Sheet: /
File: HW−262_kicad.kicad_sch

Title: Multi−Function Shield for Nucleo C031

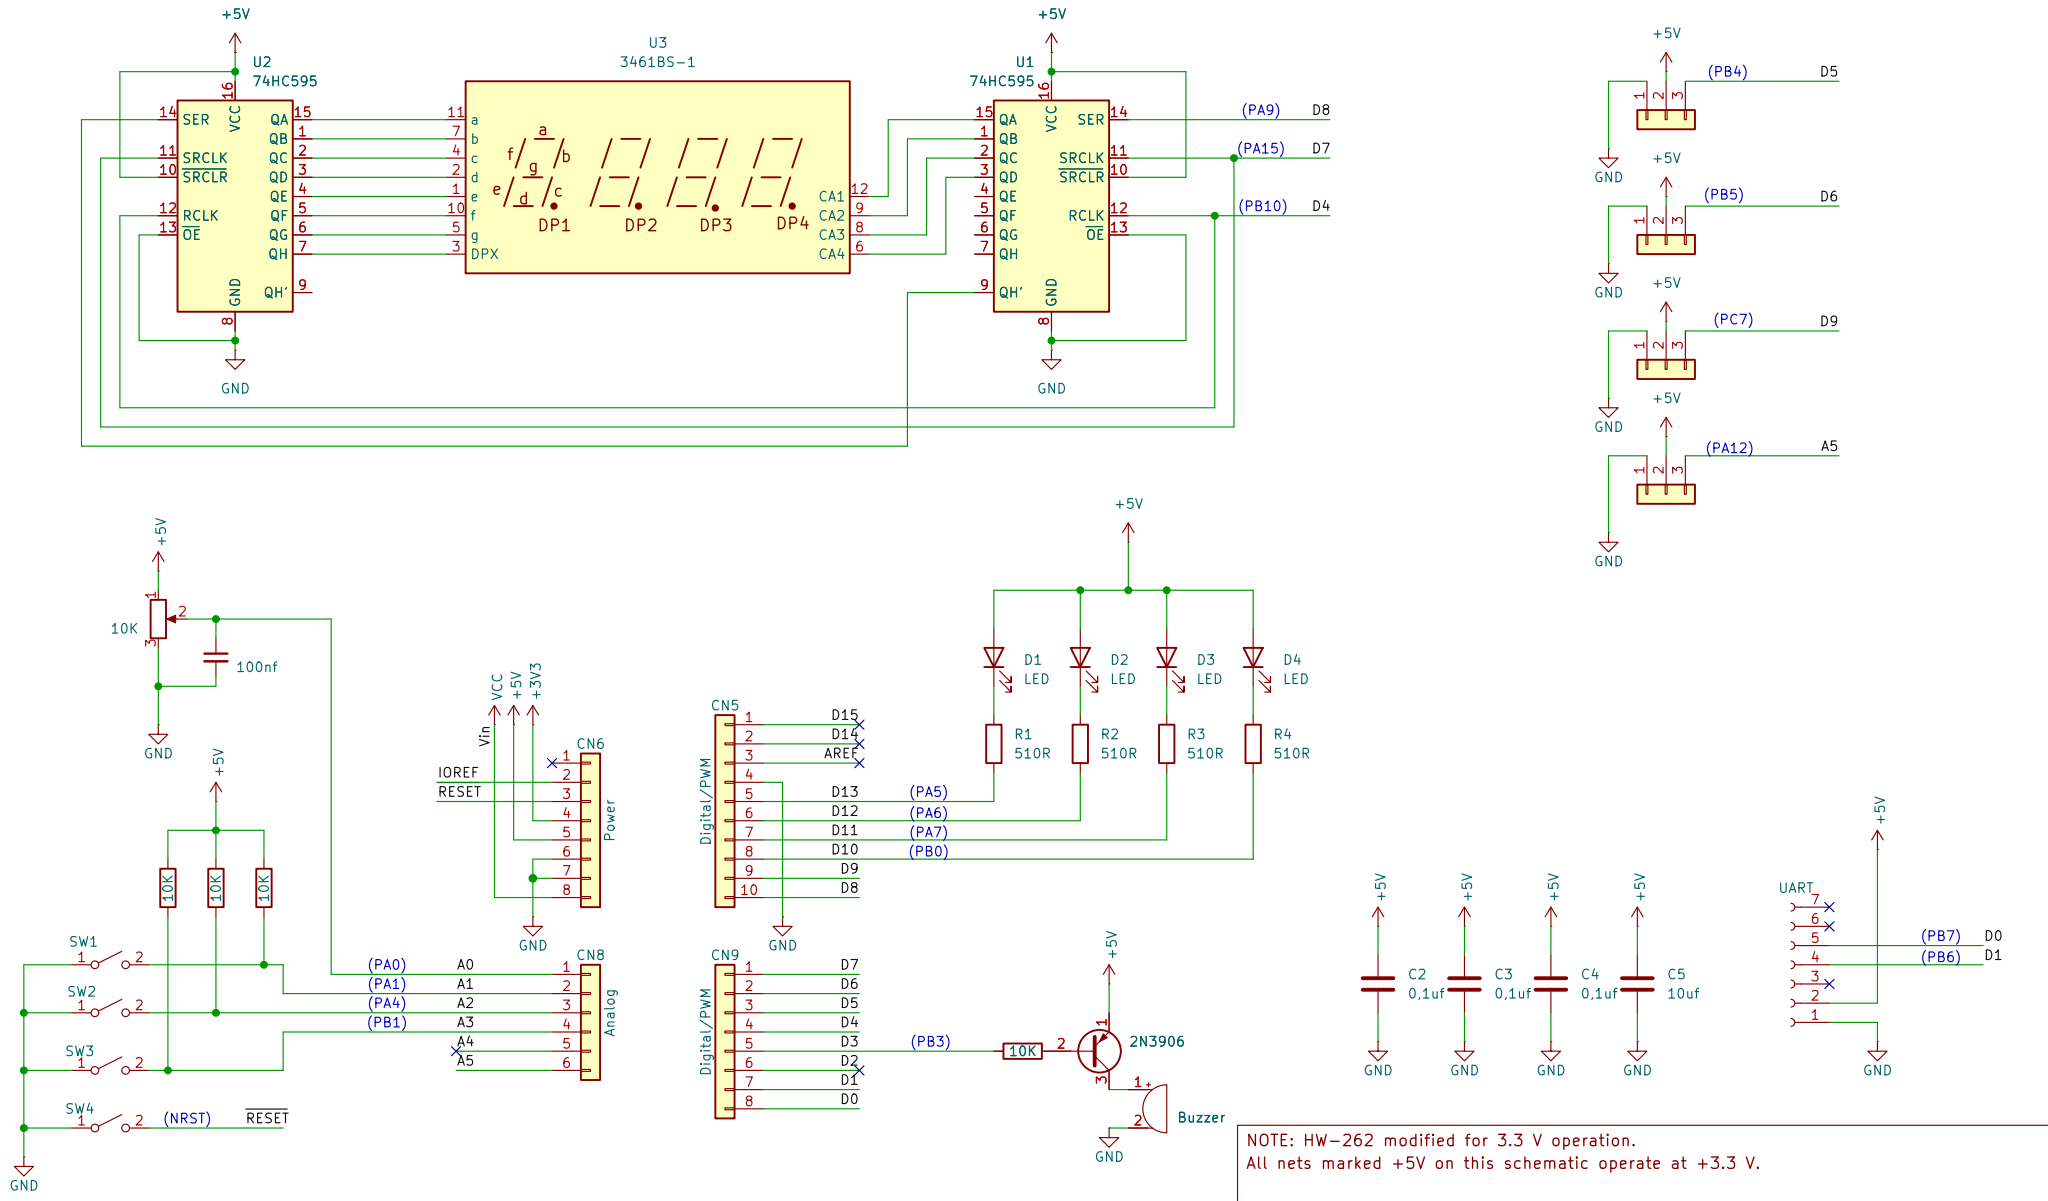
NOTE: HW−262 modified for 3.3 V operation.

Original +5 V Arduino pin removed and HW−262 +5 V rail connected to Arduino +3V3. All nets marked +5V on this schematic operate at +3.3 V.
